SUBJECT: Supplement to the Application for Certification
Rio Mesa Solar Energy Generating Facility (11-AFC-4)

Response to Data Adequacy Review of the APPLICATION FOR CERTIFICATION for the Rio Mesa Solar Electric Generating Facility

(11-AFC-04)

This Supplement to the Rio Mesa Solar Electric Generating Facility (Rio Mesa SEGF) Application for Certification (AFC) (11-AFC-04) responds to comments that California Energy Commission (CEC) Staff have made as a result of their data adequacy review of the AFC. This Supplement provides all additional information necessary for Staff to find that the AFC contains sufficient and adequate data to begin a 12-month power plant site certification proceeding under Title 20, California Code of Regulations and the Warren-Alquist Energy Resources Conservation and Development Act.

Figure 2-15 – Power Block Elevation View looking east

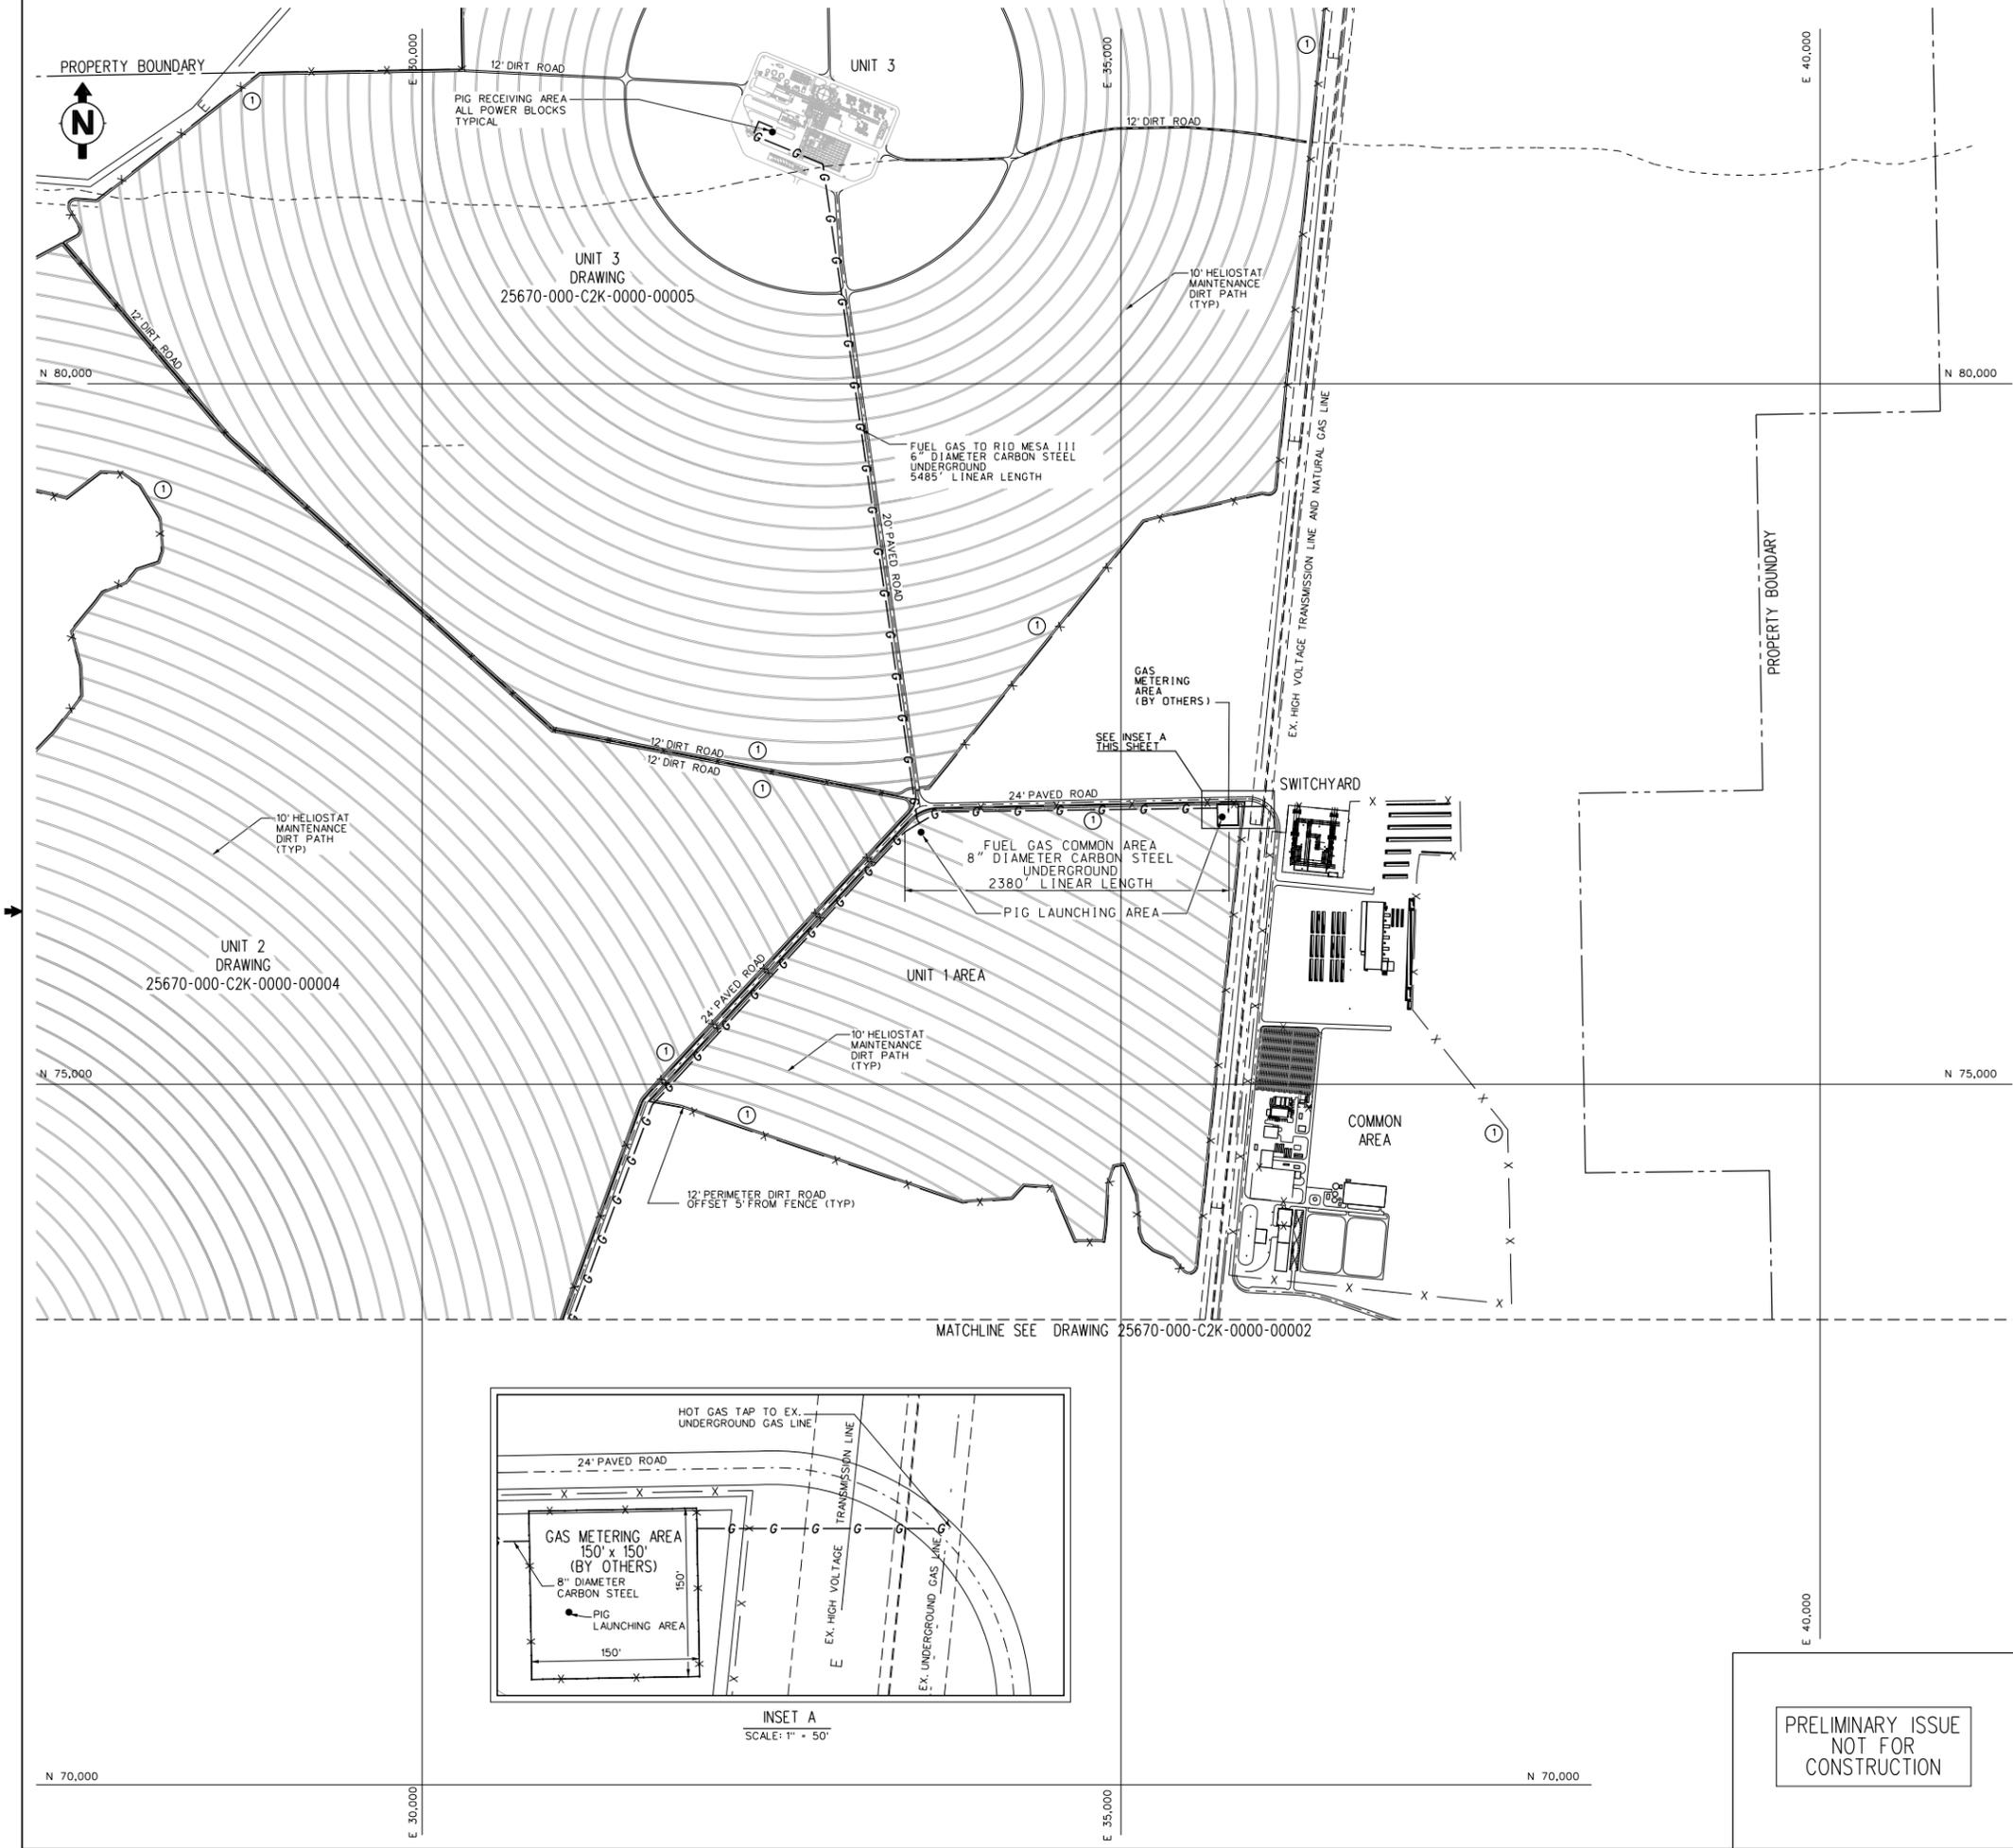
Provide scaled plans and elevation drawings (all four sides) of the power plant and all related facilities (e.g. power block area with associated buildings and facilities, common area with associated buildings and facilities, a heliostat, etc.).

Response: Attached are the following scaled plans and elevation drawings representing the power plant and all related facilities.

RIO MESA SOLAR ELECTRIC GENERATING FACILITY
RIO MESA UNIT 1 AREA (PART) AND COMMON AREA UNDERGROUND GAS LINE LOCATION PLAN
OWNER DRAWING NO.

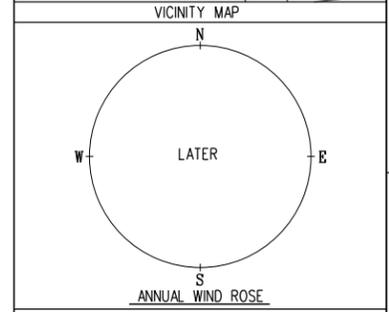
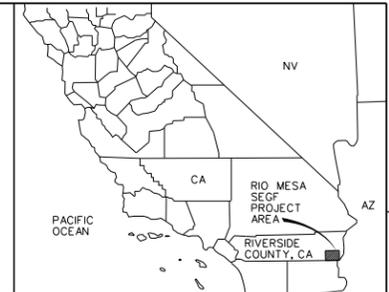
Please provide a description of the length and location of the proposed gas lines from each power block to the proposed metering station as well as map showing the proposed locations of the gas lines.

Gas Pipeline Common – all (Figure 2-2): This underground leg is a common natural gas pipeline for all three plants from the gas metering station to the point at which the gas pipeline for Rio Mesa Solar III tees off. The new gas meter station which is to be constructed, owned, and operated by TransCanada Gas Transmission Company (TGTC) is located in the extreme northeastern corner of the Rio Mesa Solar I solar field. The common natural gas pipeline to Rio Mesa Solar I, II, and III follows the common paved access road for a distance of approximately 2,380 feet.

TYPICAL VIEW OF POWER BLOCK FROM THE NORTHWEST FACING SOUTHEAST
 RIO MESA SOLAR
 ELECTRIC GENERATING FACILITY

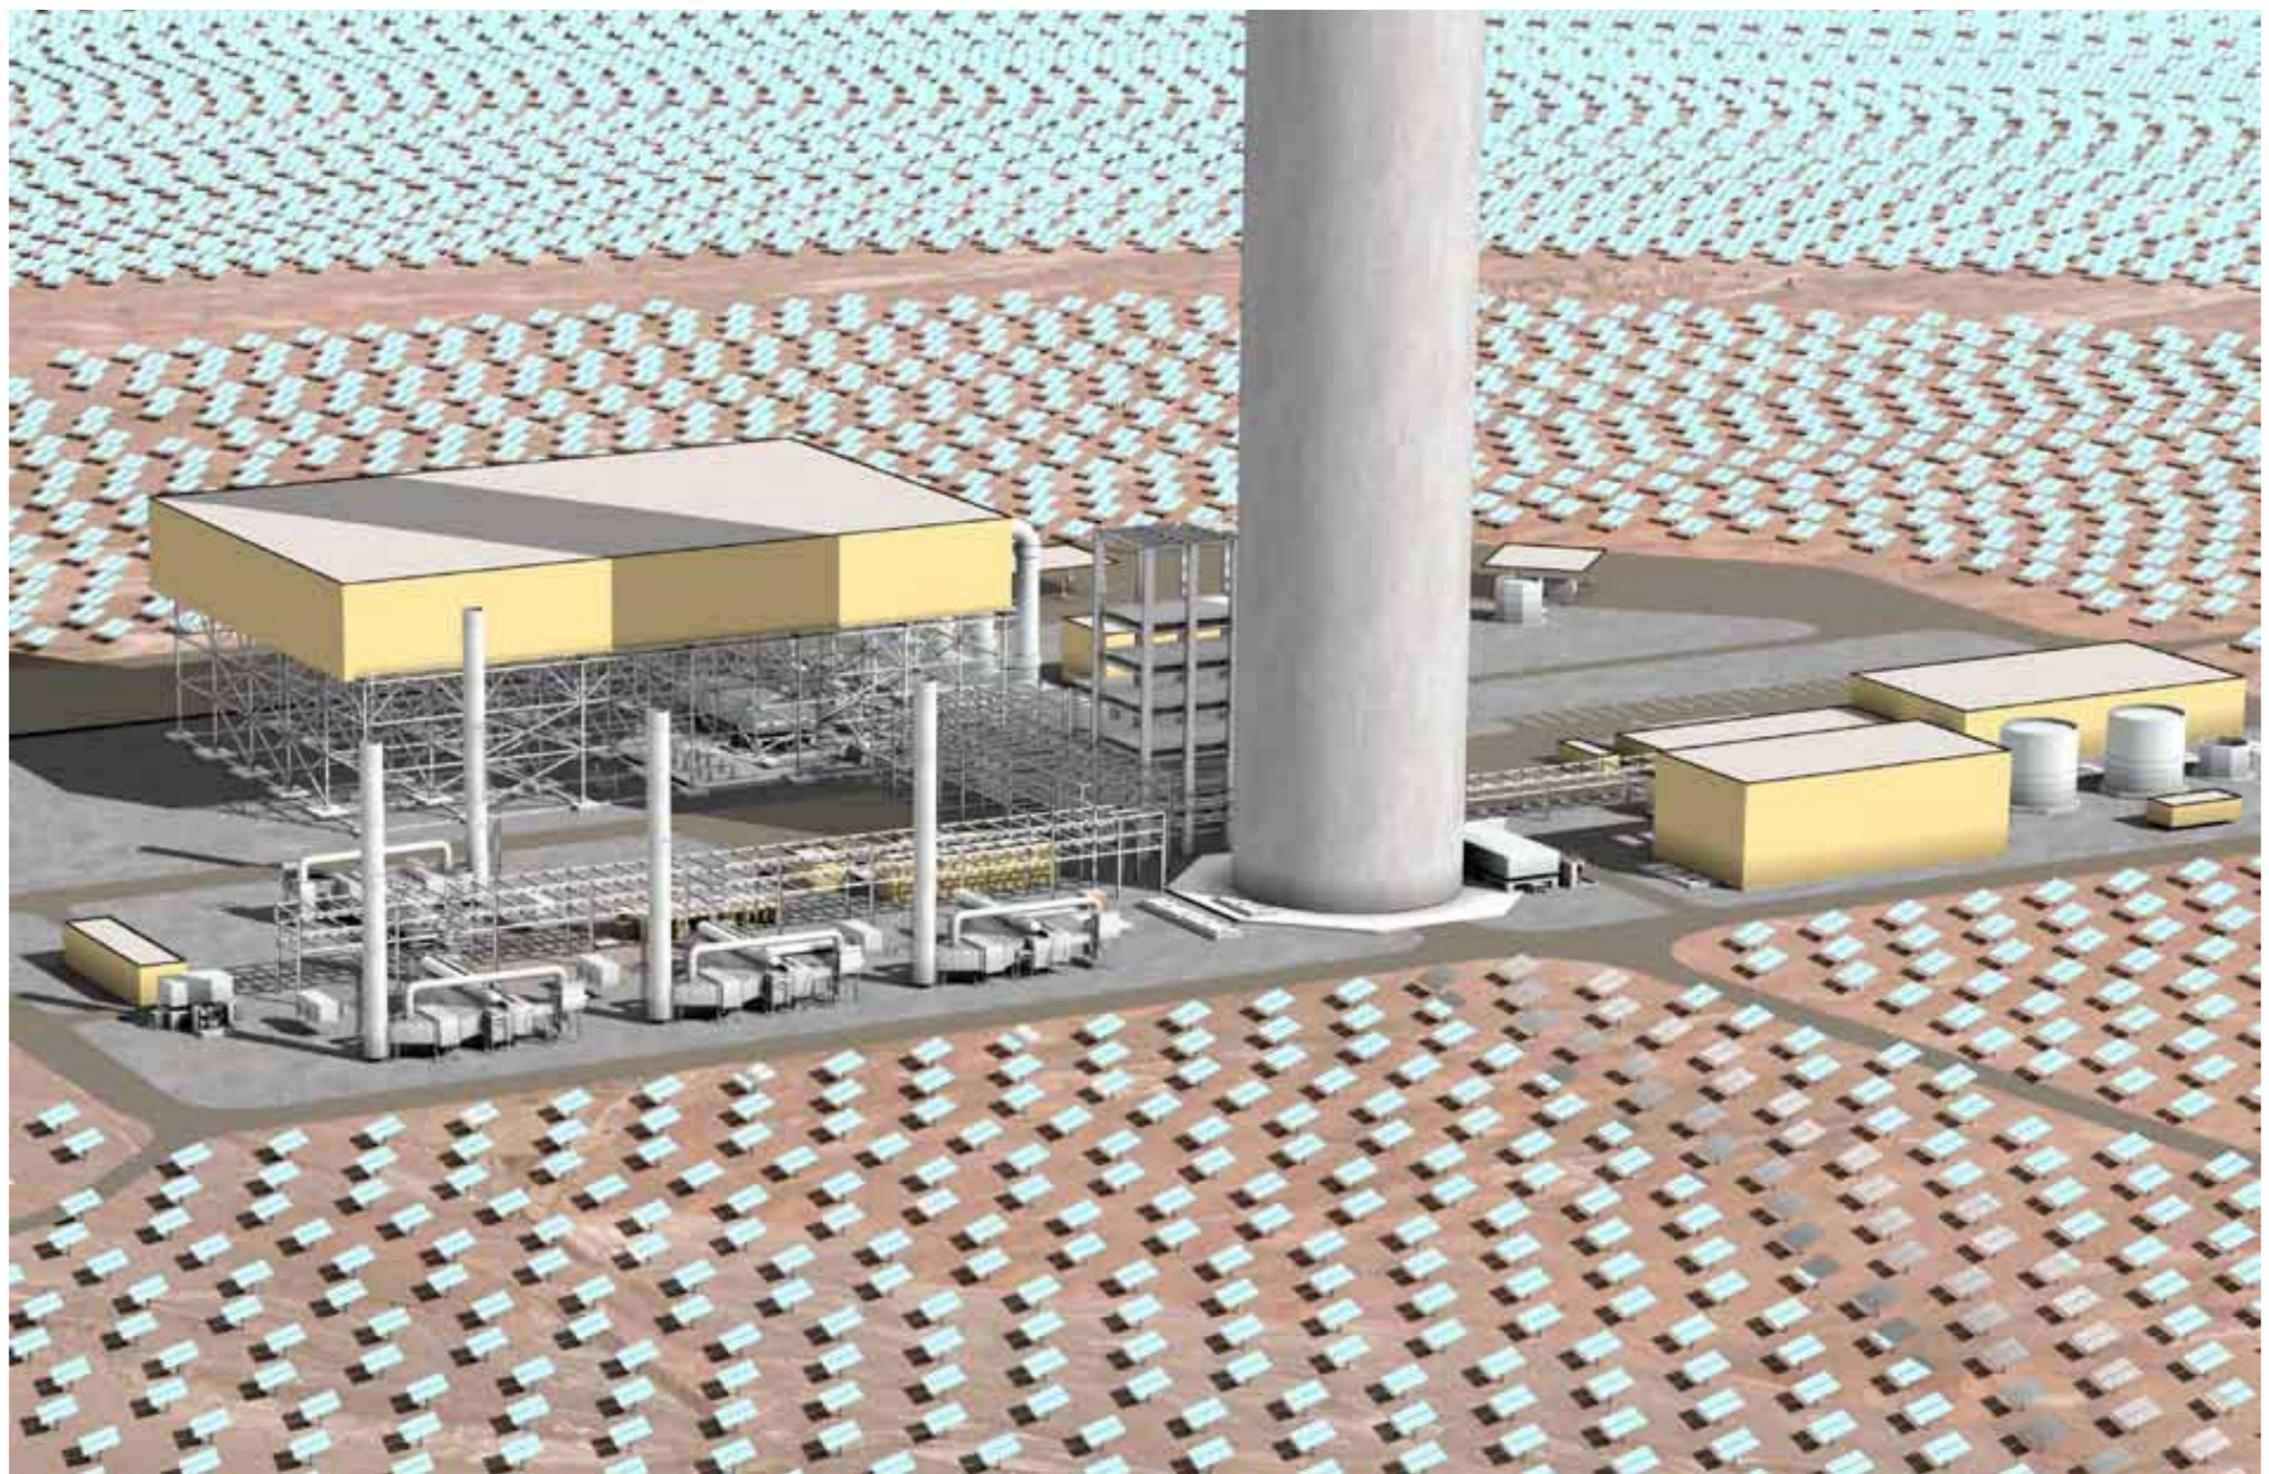
Provide an artist's rendering representative of one of the power blocks and the surrounding facilities/components.

Response: The attached figures represent typical close up views of the power block and surrounding facilities/components at Rio Mesa SEGF.
